Access Report

State Significant Development Application (SSDA) – Rev C

Project Duke Data Centre – 2 & 10-22 Kent Road & 685 Gardeners Road, Mascot NSW 2020

Our Ref: 24000870 | Issue date: 21 May 2025

D4D5 Ground Floor

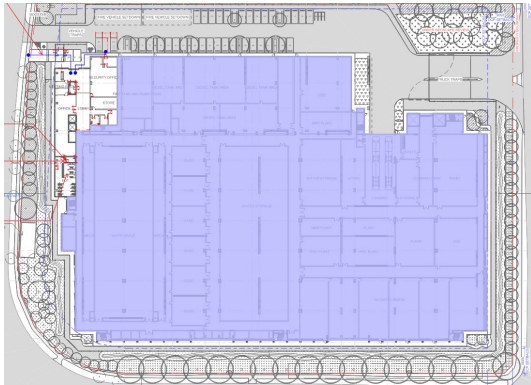
The documentation review has identified that the areas or rooms highlighted in purple require further clarification to demonstrate exemption under NCC/BCA D4D5. These areas are not required to be accessible due to their specific use and user group, as they meet one or more of the following criteria:

Where the above is applicable the client must provide a letter detailing why this is applicable (e.g. store of heavy equipment, furniture, hazard substances, etc) to this building and clearly note locations. Letter to be assessed as part of this OC sign off.

Level 02 Floor

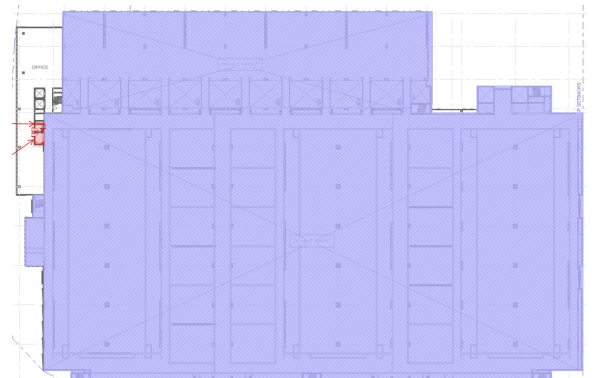
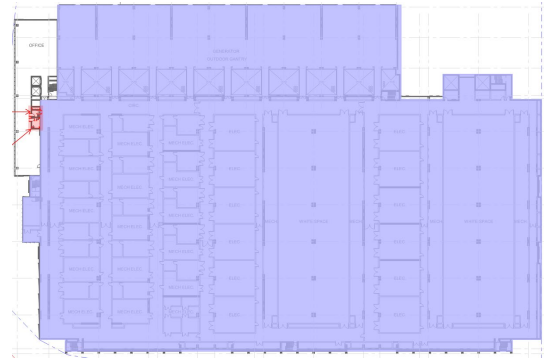
This generally applies to plant rooms and other areas used occasionally by maintenance personnel. It should preclude wheelchair access from these areas.
